Questions regarding the Preliminary scheme for the temporary placement of Stair Tower 1 (as presented by C3D)

At the request of Chubb Insurance and Rosner, Nocera, & Ragone, LLP, DBI was assigned to analyze the claim submitted on August 11, 2015 in order to provide our opinion of the required scope of work and associated pricing to repair damage to a multi-use building located at 129 Third Avenue, New York, NY 10003.

Coral Realty 129 Third Ave, New York, NY 10003 GGG/Al Proposed Staircase Structure Diagram

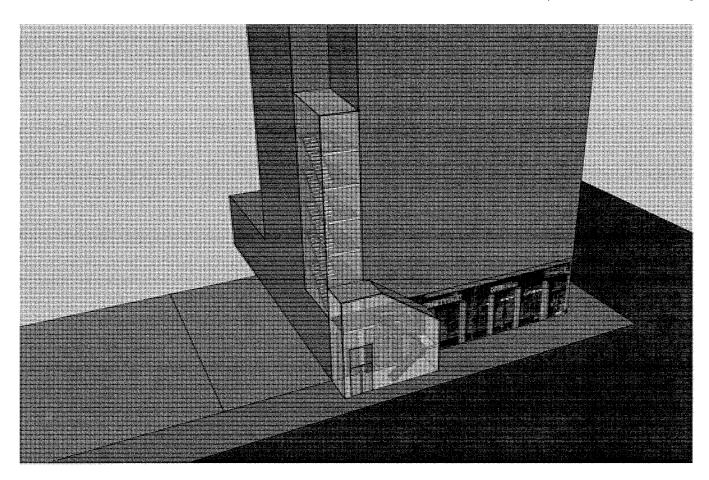
Based on the adjustment team's preliminary study of the NYCDOB requirements, a light metal stair tower (scaffolding type structure) can be sufficient to provide temporary egress while repairs are being completed. Please advise what NYCDOB requirements the claimed stair structure is based upon.
